**THE PORT AUTHORITY OF NEW YORK AND NEW JERSEY
TWO MONTGOMERY STREET - 1st FLOOR
JERSEY CITY, NJ 07302**

ADDENDUM NO. 11

TO PROSPECTIVE BIDDERS ON CONTRACT **EWR-154.395** – NEWARK LIBERTY INTERNATIONAL AIRPORT – TERMINAL A REDEVELOPMENT PROGRAM BRIDGES N61, N62, N63, AT-GRADE ROADWAYS AND APPURTENANCES AND CONTRACT **EWR-154.395M** – NEWARK LIBERTY INTERNATIONAL AIRPORT – AGREEMENT TO PERFORM LANDSCAPE MAINTENANCE

SKETCH SK-E01
ADDENDUM NO. 11

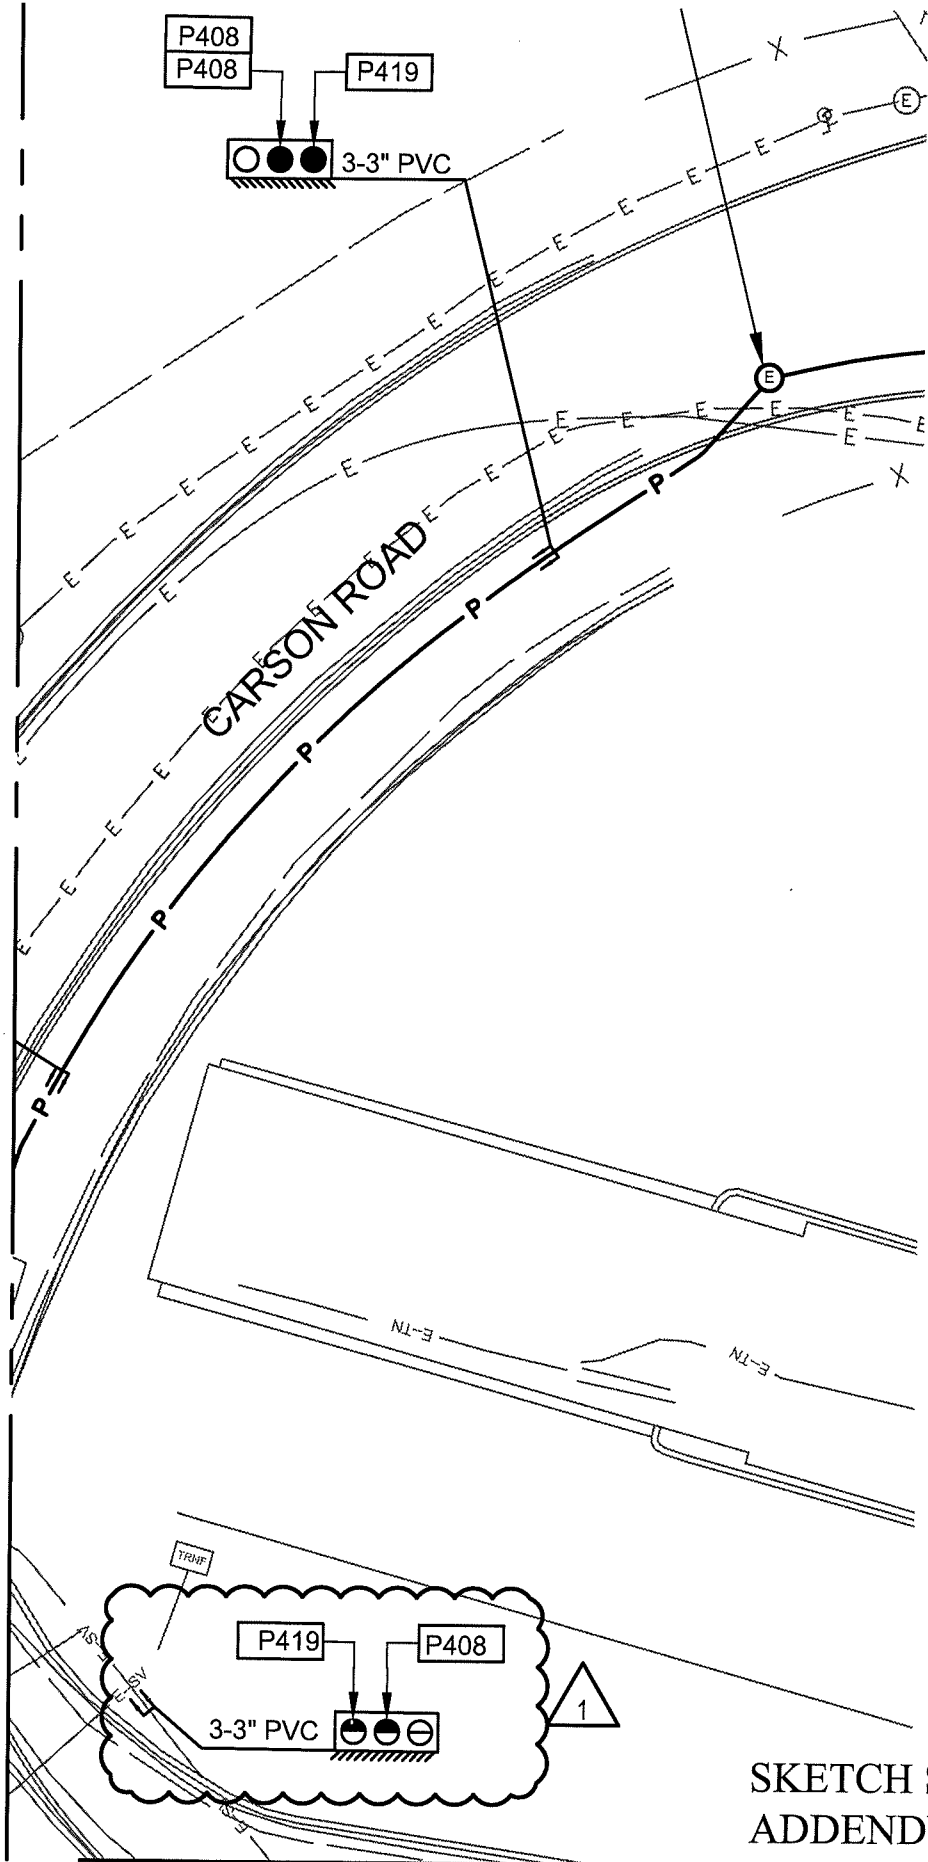
- Dwg. G0104 - In the "GENERAL NOTES", immediately following Note 16. insert the following new note:
- "17. THE AUTHORITY WILL BE IDENTIFIED AS THE GENERATOR ON WASTE MANIFESTS AND ANY OTHER DOCUMENTATION SUBMITTED TO TRANSPORTERS, DISPOSAL FACILITIES AND ANY GOVERNMENTAL ENTITY FOR PRE-EXISTING HAZARDOUS MATERIALS TO BE DISPOSED AS PART OF THE WORK."
- Dwg. C0201 - Revise the drawing as shown in Sketch SK-C01 which is attached hereto and made a part hereof.
- Dwg. E1008 - Revise the drawing as shown in Sketch SK-E01 which is attached hereto and made a part hereof.
